To: Elizabeth Mursko, City Administrator, City of Columbus

From: Haila Maze, Senior Planner, Bolton & Menk

Re: Review of Draft Anoka County Comprehensive Plan

I've reviewed the draft Anoka Comprehensive Plan, provided to the City of Columbus for review and comment by county staff as part of the six-month interjurisdictional review required by the Metropolitan Council.

APPENDIX: ANOKA COUNTY PARKS, TRAILS, AND STATE LANDS MAP

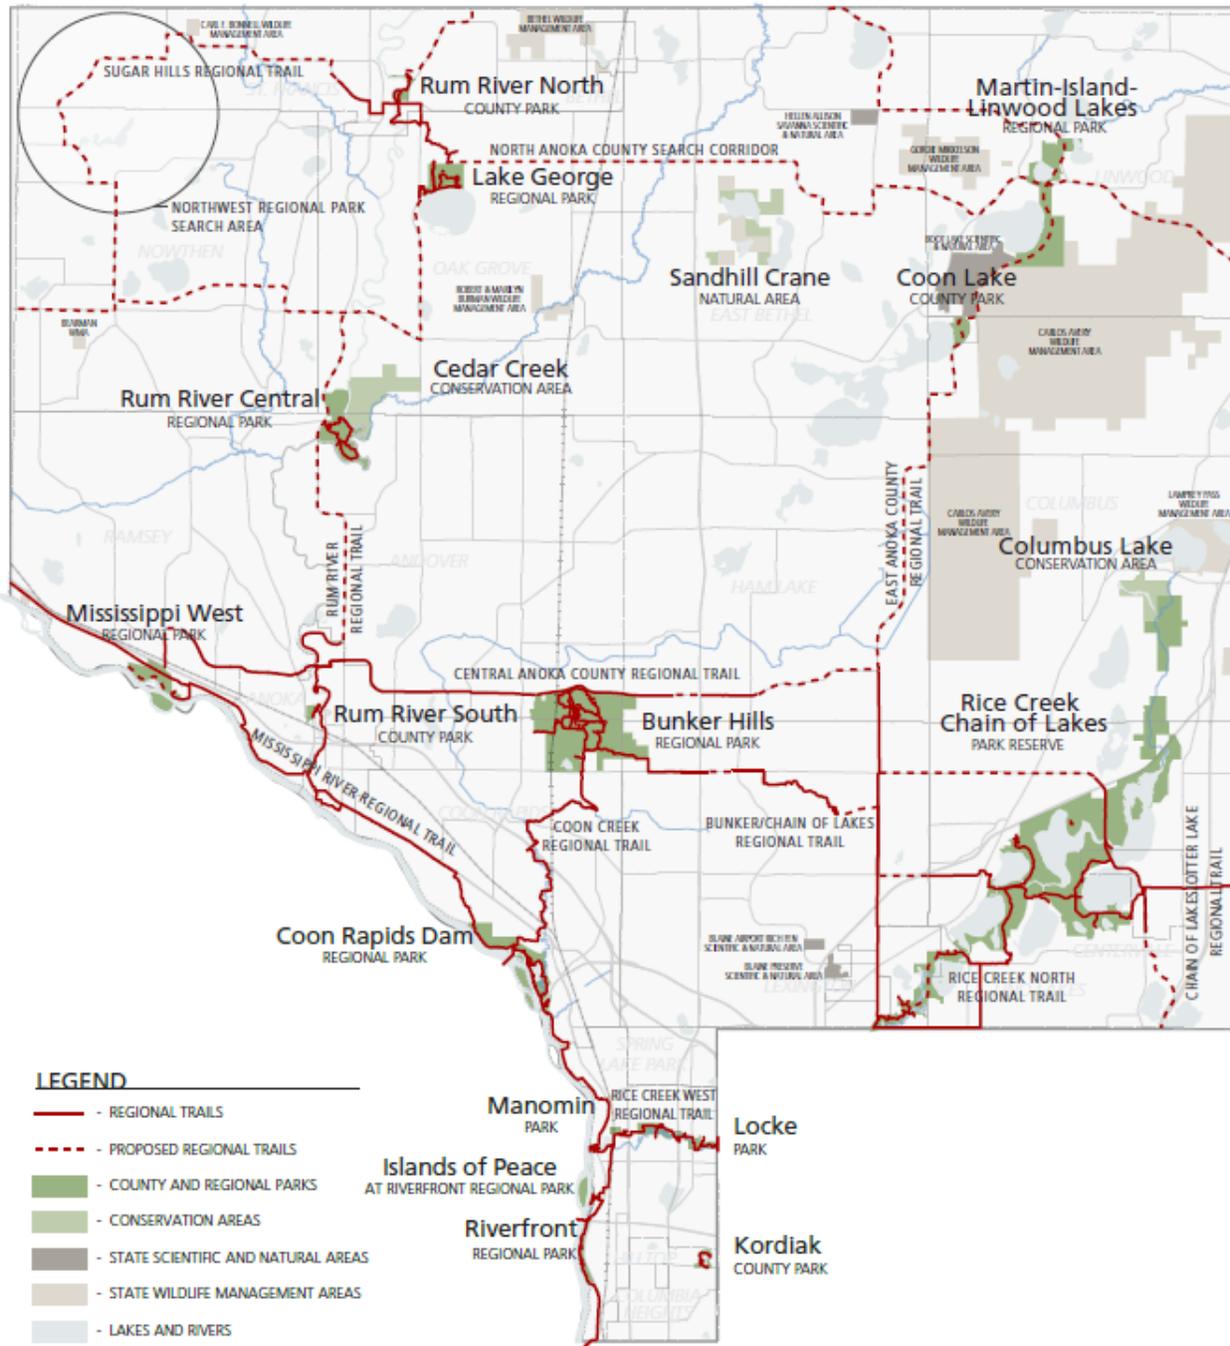
- The plan identifies several existing park and other protected open space areas within the City of Columbus. They appear to be largely consistent with city maps, although the scale in the plan makes it difficult to compare at the individual parcel level

- The plan also shows existing snowmobile trail and existing/future regional trail corridors. These do not appear to be inconsistent with the city's plan.

- The plan does not appear to call for any specific improvements to the parks in Columbus, except for the future East Anoka County Regional Trail.

FIGURE 27

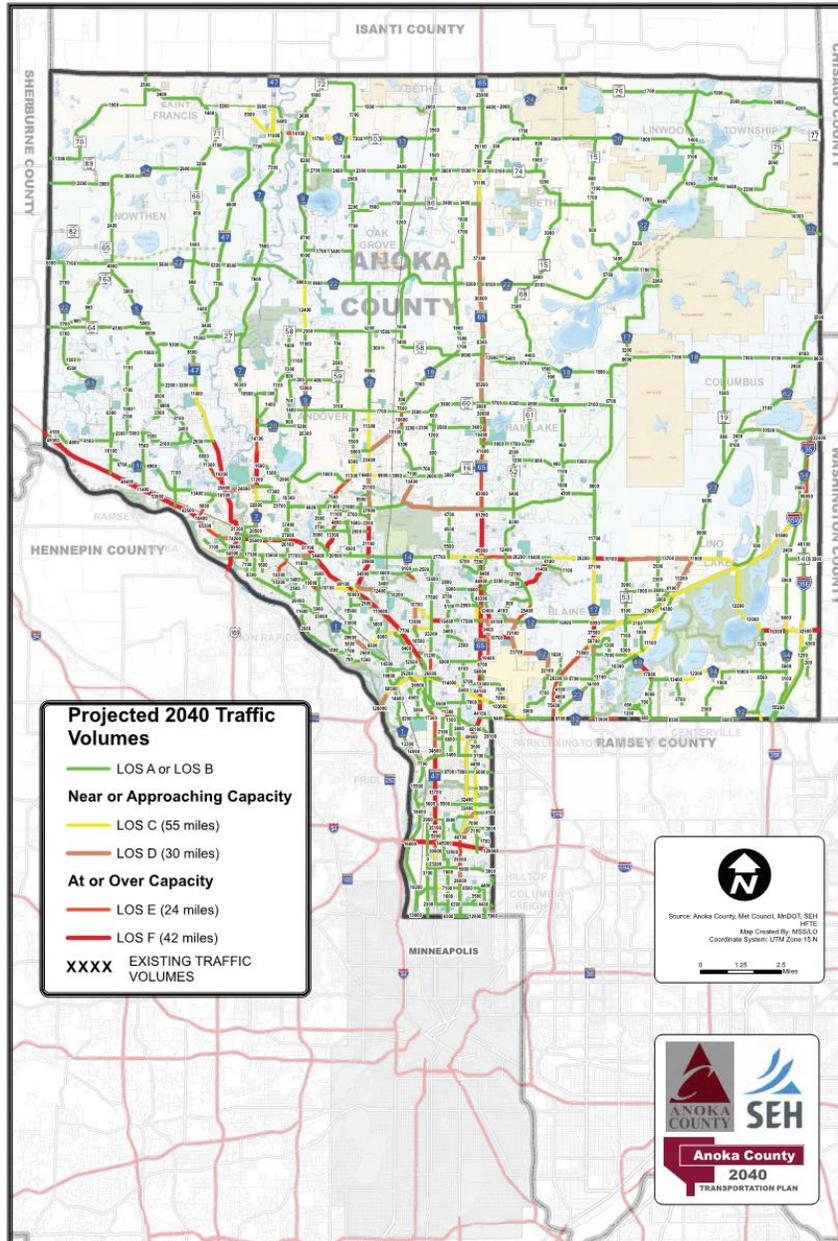
- As the City of Columbus used the county transportation model results, there is consistency between the two in terms of forecasted traffic. No corridors outside of the interstate system are expected to be over capacity or approaching capacity by 2040.

FIGURE 29

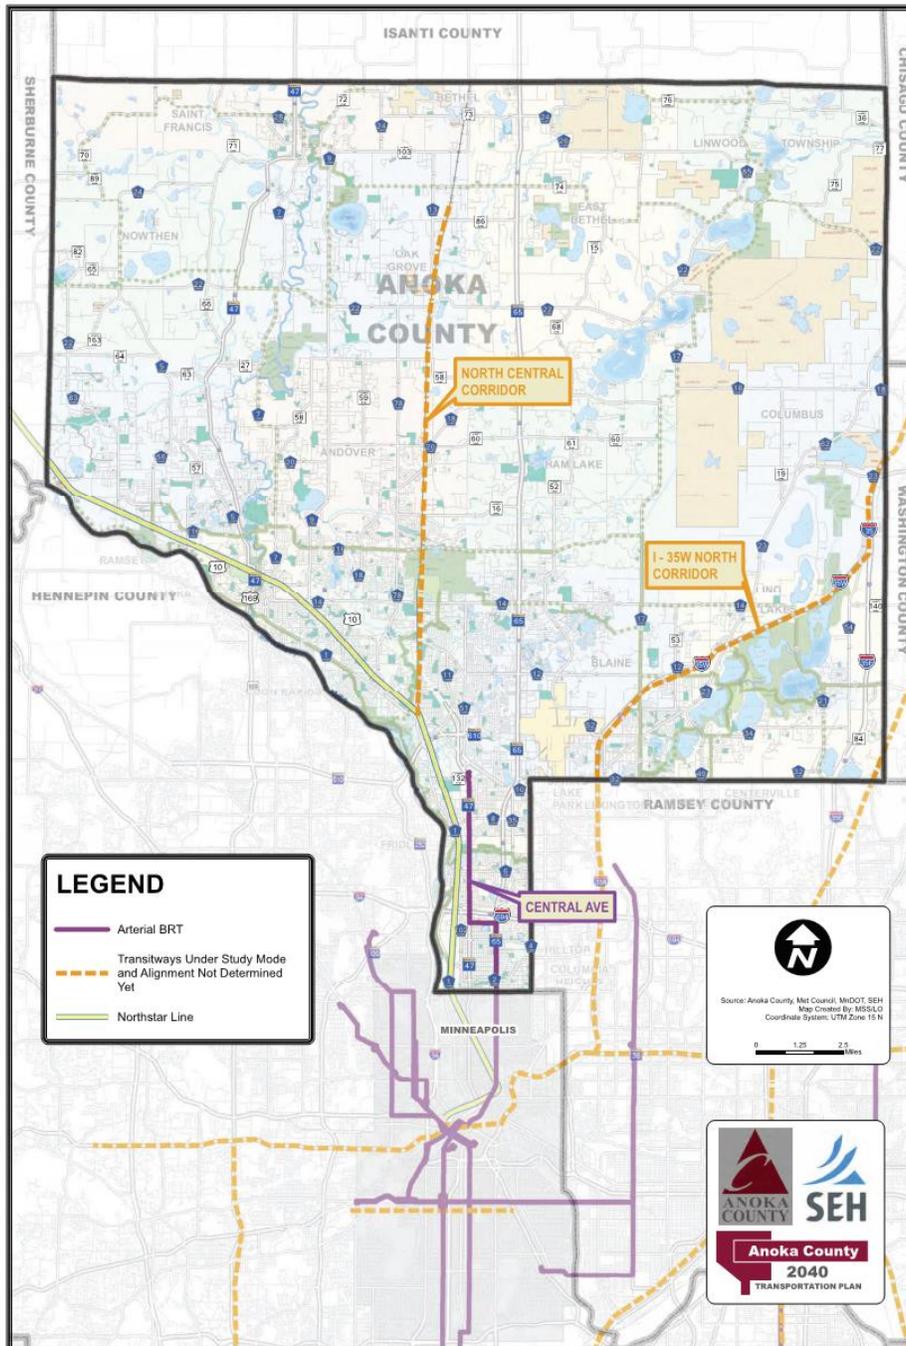
- The transit element shows a potential future transitway on I-35W/I-35 from the Metropolitan Council’s Increased Revenue Scenario. No details are provided regarding the type of facility or timing, and there is no funding identified.

FIGURE 34

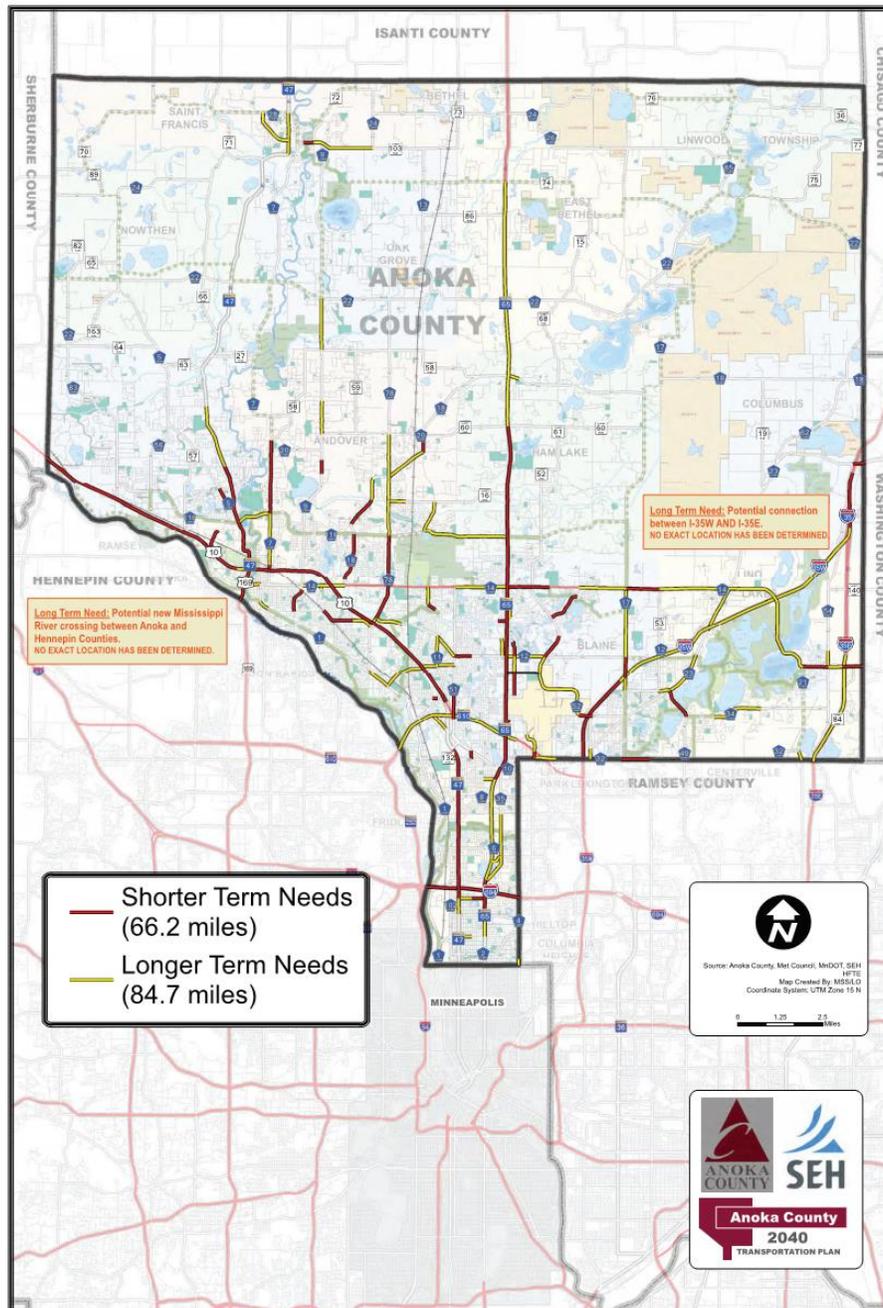
- The plan identifies roadway improvements based on level of priority – either short or long term. In Columbus, this includes improvements on Lake Drive in the vicinity of the I-35 interchange, as well as improvements to I-35W south of the interchange. Some of this work is already underway. It also calls out a future connection between I-35W and I-35E (as recommended in the Lino Lakes plan), but does not identify a location, funding, or timing for that project.

FIGURE 35

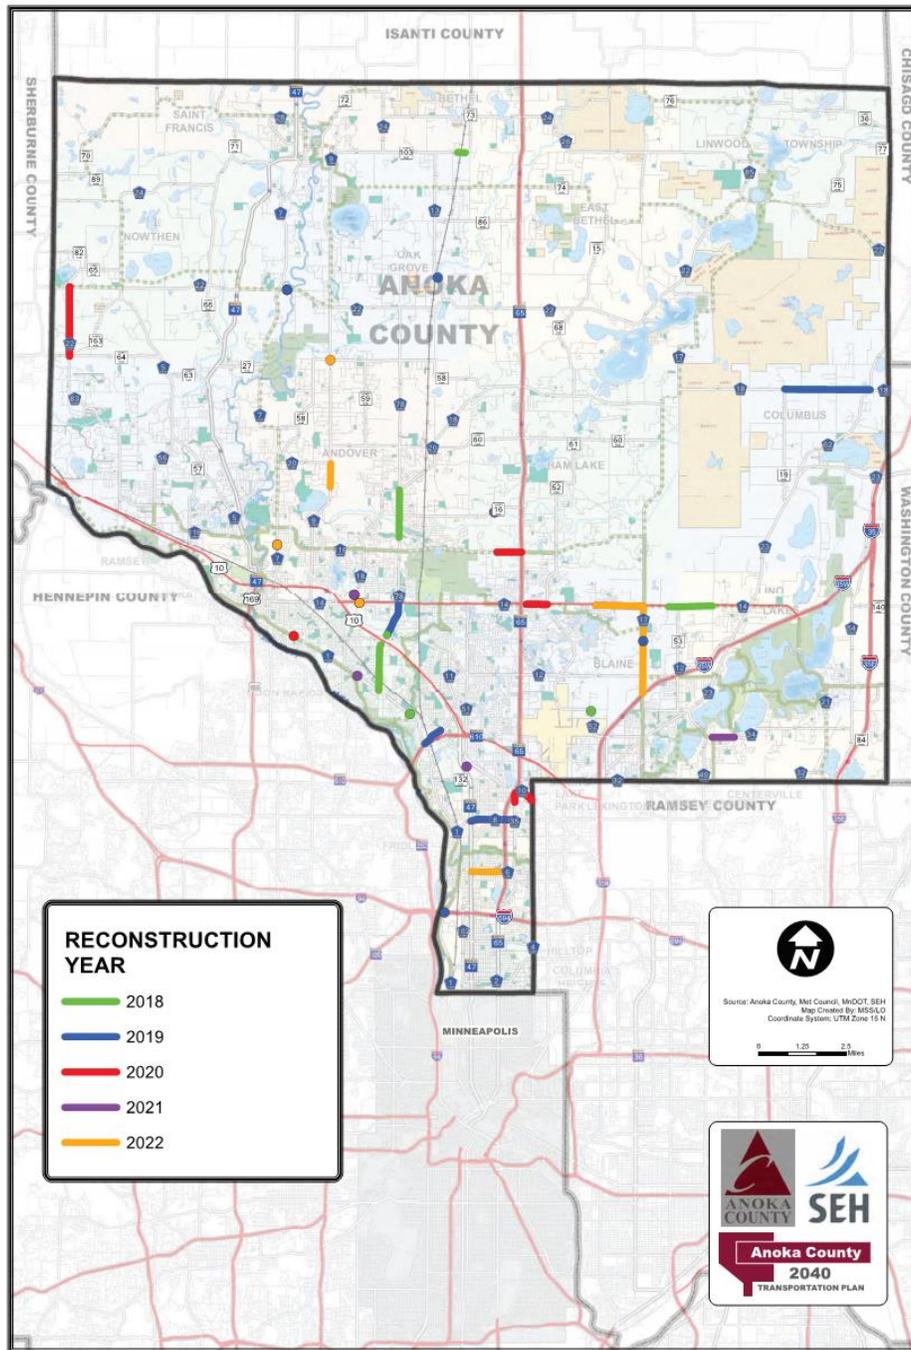
- The plan identifies CSAH 18 in Columbus for repaving in 2019, as part of a five-year plan. No other projects in the city are identified.
